**Economic Commission for Europe****Inland Transport Committee****World Forum for Harmonization of Vehicle Regulations****Working Party on Passive Safety****Seventy-sixth session**

**UN Regulation No. 134 (Hydrogen and Fuel Cell Vehicles)****Proposal for Supplement 2 to the 02 Series of Amendments to UN Regulation No. 134 (Hydrogen and Fuel Cell Vehicles)****Submitted by the Task Force amending UN Regulation No. 134 \***

"Figure 2

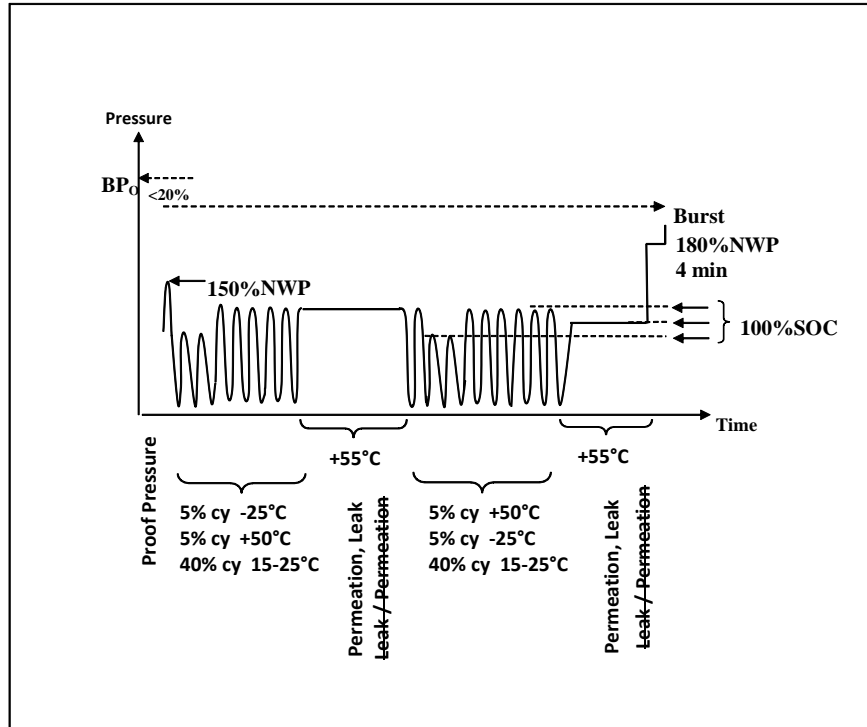
Figure 2., amend to read:

### Verification Test for Expected On-Road Performance (Pneumatic/~~hydraulic~~)

This proposal clarifies the order of the permeation and leakage tests in Figure 2 so as to be in line with the text, and also streamlines the wording for headings and text relating to these tests.
